HOLLISTER PLANNING COMMISSION AGENDA

Regular Meeting
December 15, 2022
6:00 PM

2. **Minor Subdivision 2018-6, Site & Architectural Review 2018-23 Extension** – Wright Thirteen, LLC – The applicant is requesting an extension for approved Minor Subdivision 2018-6 and Site & Architectural Review 2018-23 to subdivide a 13.19-acre parcel into four lots consisting of 4.25 acres, 4.01 acres, 4.07 acres, and 0.86 acres. The approval includes Site & Architectural approval to construct approximately 340,000 square feet of indoor greenhouse buildings for a cannabis cultivation facility on existing agricultural land, including onsite parking and all utility connections, drainage, and landscape improvements. The project site is located at Wright Road and San Felipe Road in the North Gateway (NG) Zoning District, further identified as San Benito County Assessor Parcel Number 053-350-005. CEQA: Mitigated Negative Declaration.

Figure 3. Revised Site Plan

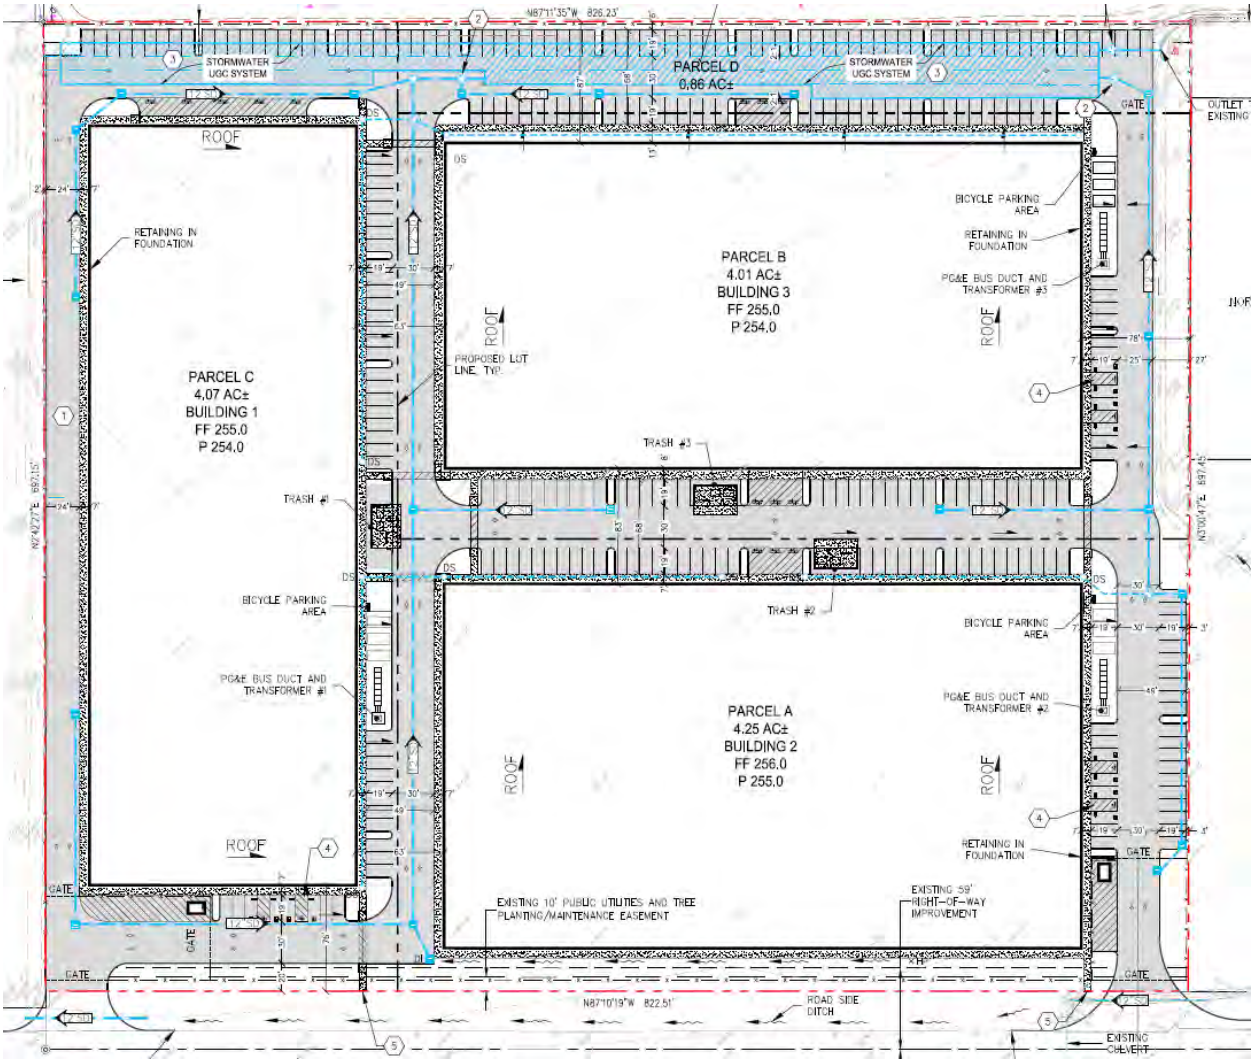
The plan set indicates inconsistent parking stall counts between "Parking Data" on Sheet C0.1 (56 spaces), and the number of spaces shown on the site plan itself (35 spaces on Parcel A, 10 spaces on Parcel B, and 10 spaces on Parcel C; total: 55). There are also two bicycle parking areas on Parcels A and C, but no space count is provided on the plans.

A1.1

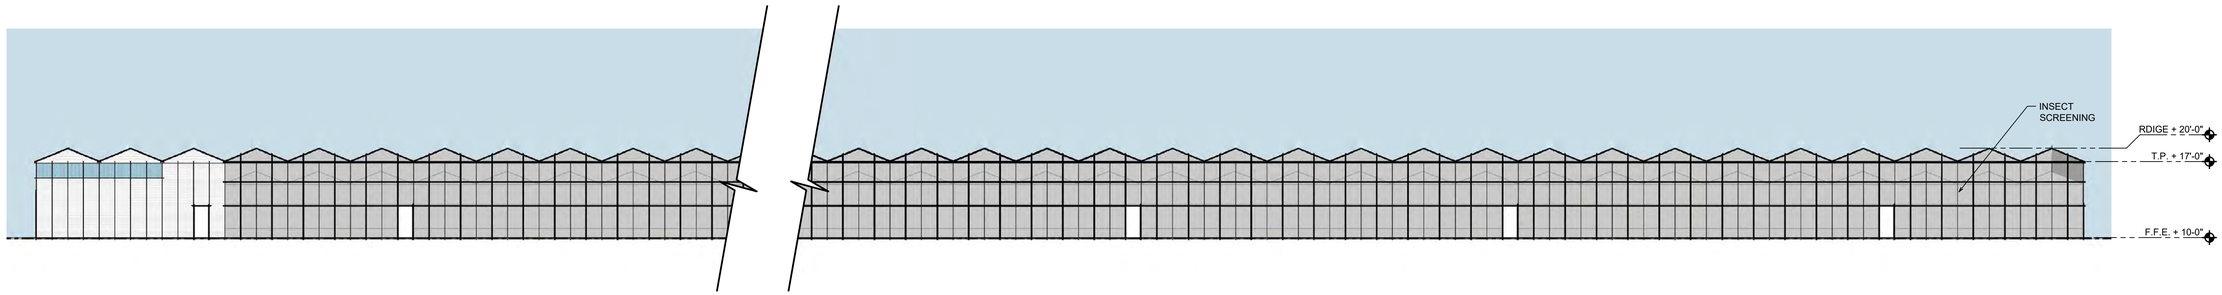
4. **Building Square Footages.** The building square footages on Sheet A1.1 total 340,870 square feet. This is 192 square feet less than the total building square footage listed on Sheet C0.1 (341,062 SF). This may very slightly affect the parking calculations in comment 1 above, but it should not affect the final numbers enough to make a different conclusion. It is also possible that the additional square footage is a part of the guard towers (discussed further in this comment letter), that are not detailed in the plans. The guard towers would not affect parking.

SHEET C1.1 OF 6

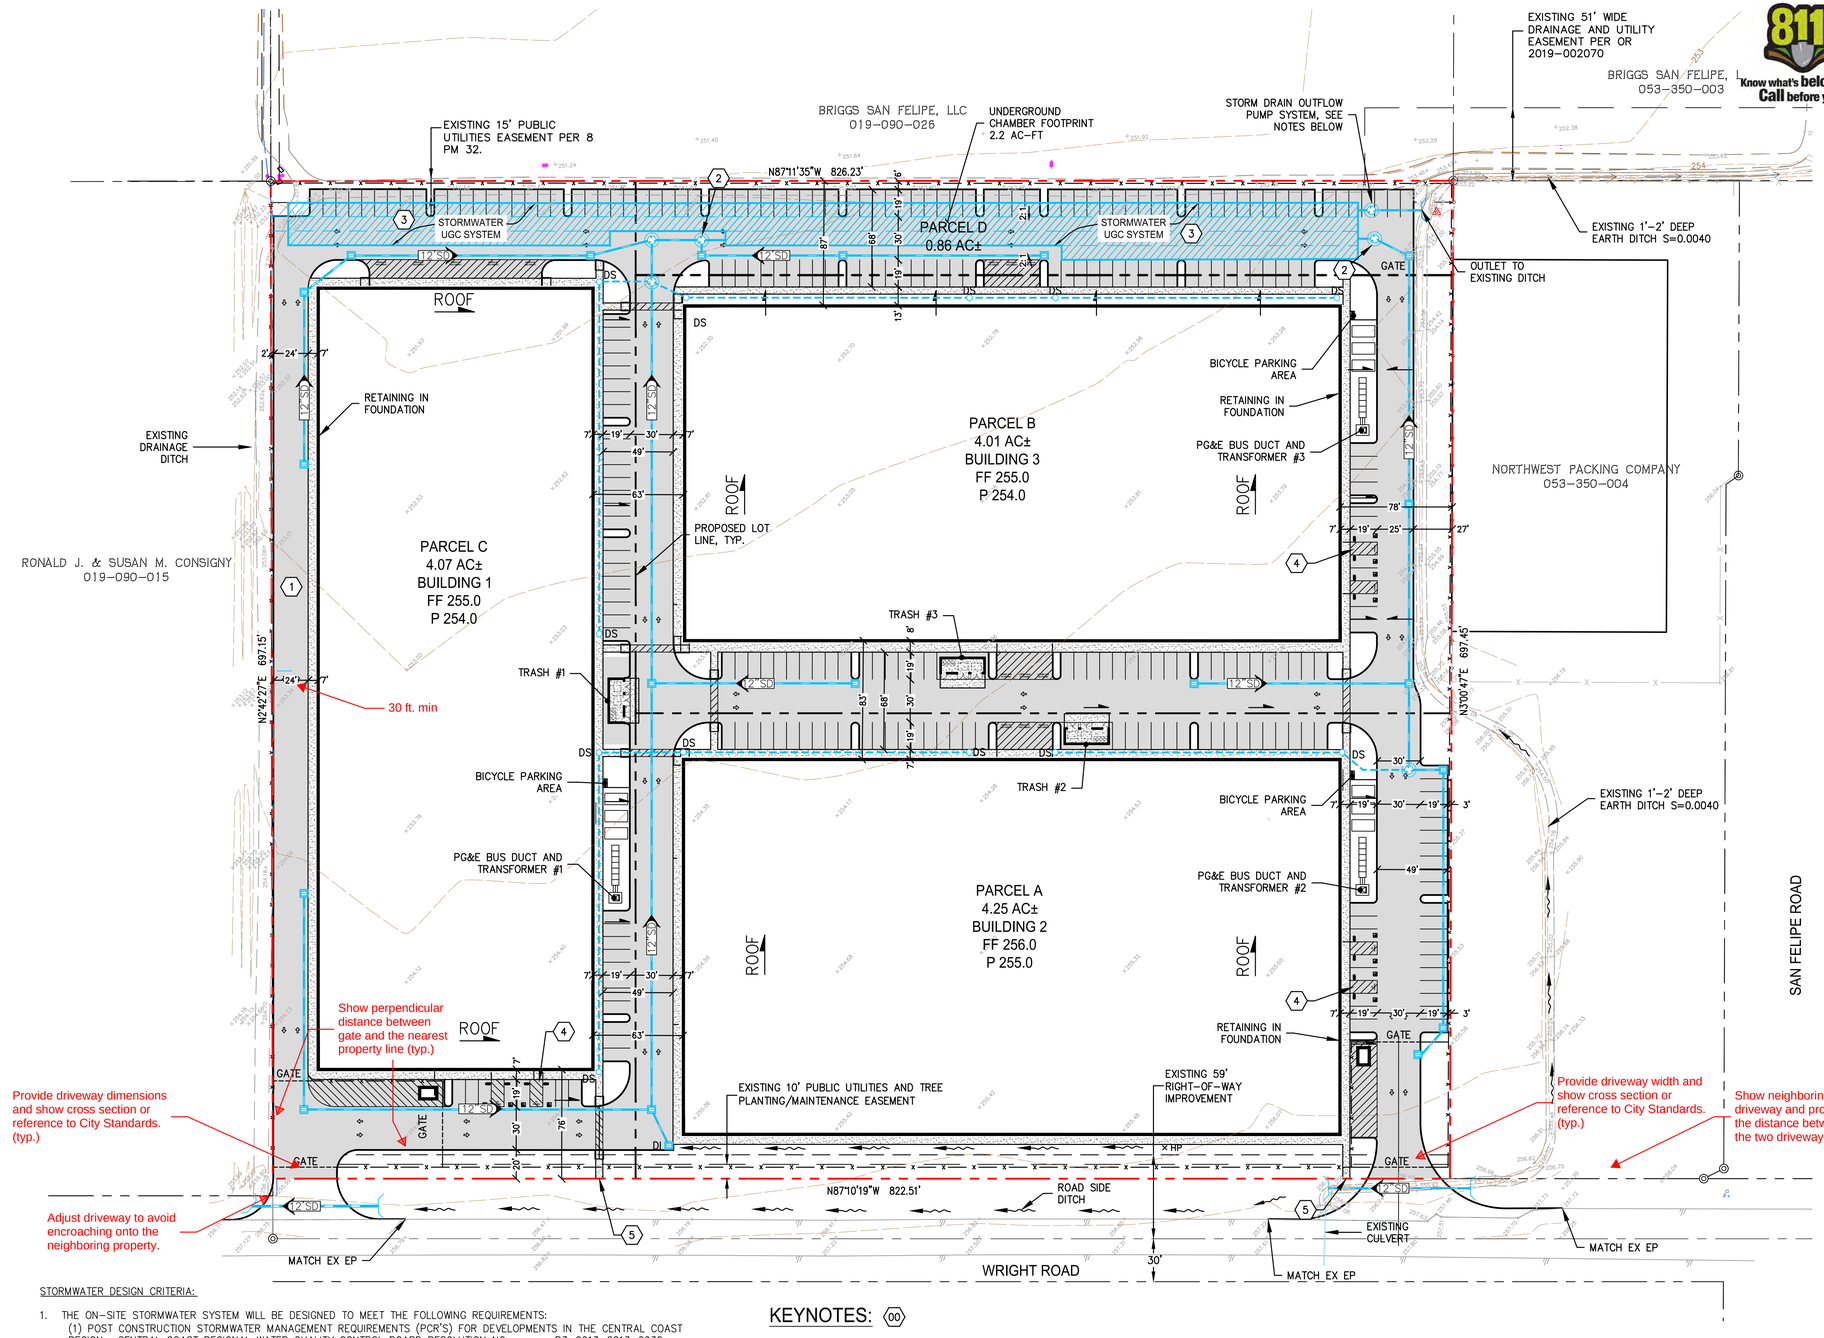
Stormwater Facilities (Sheet C1.1):

SHEET
L1.1

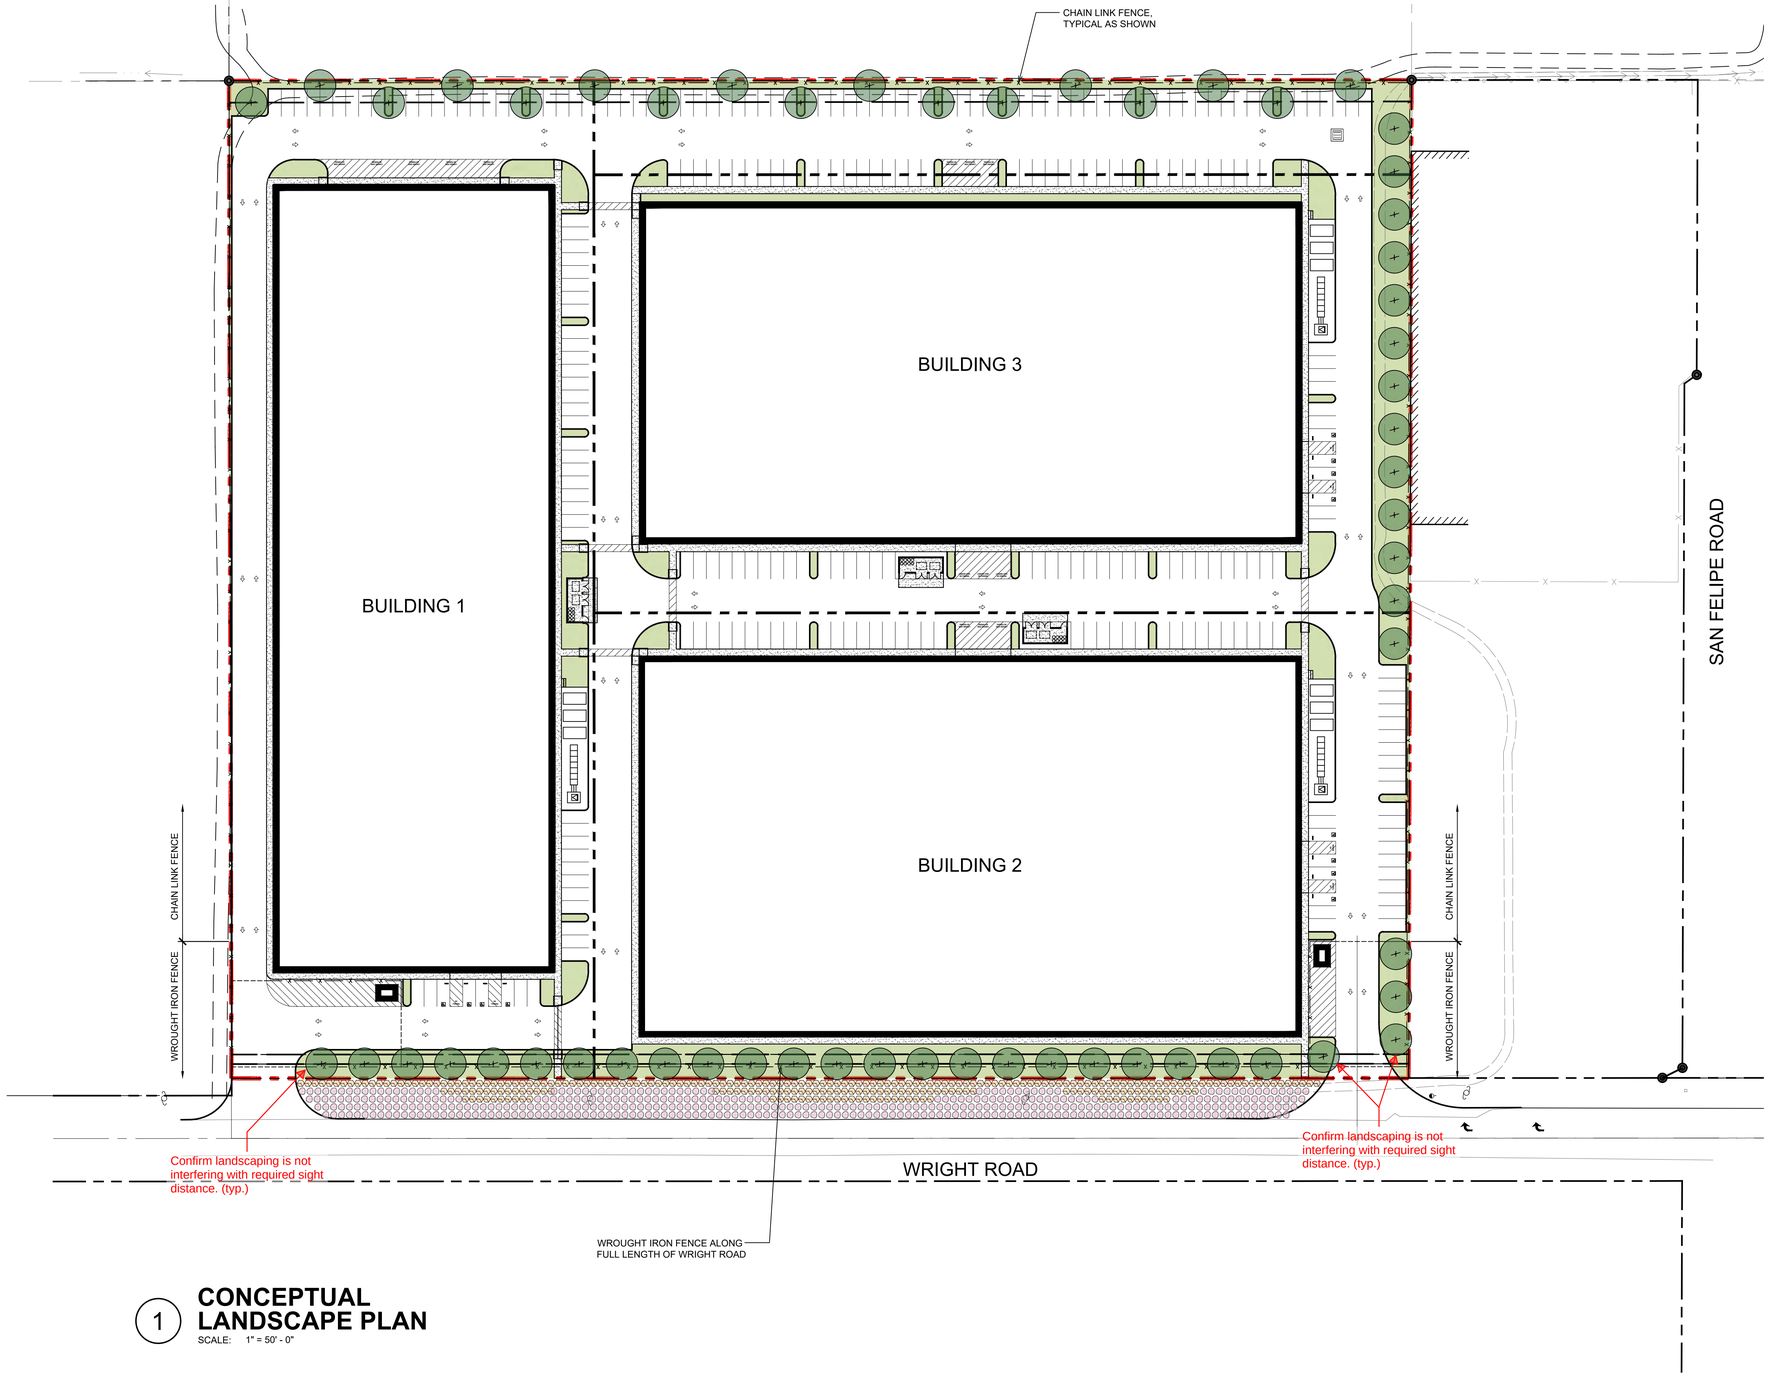
7. **Landscaping.** The following comments are made regarding the revised landscape plan (Sheet L1.1).

8. **Fence Details.** Details of the proposed fences – indicated as both wrought iron and chain link on Sheet L1.1) have not been provided.
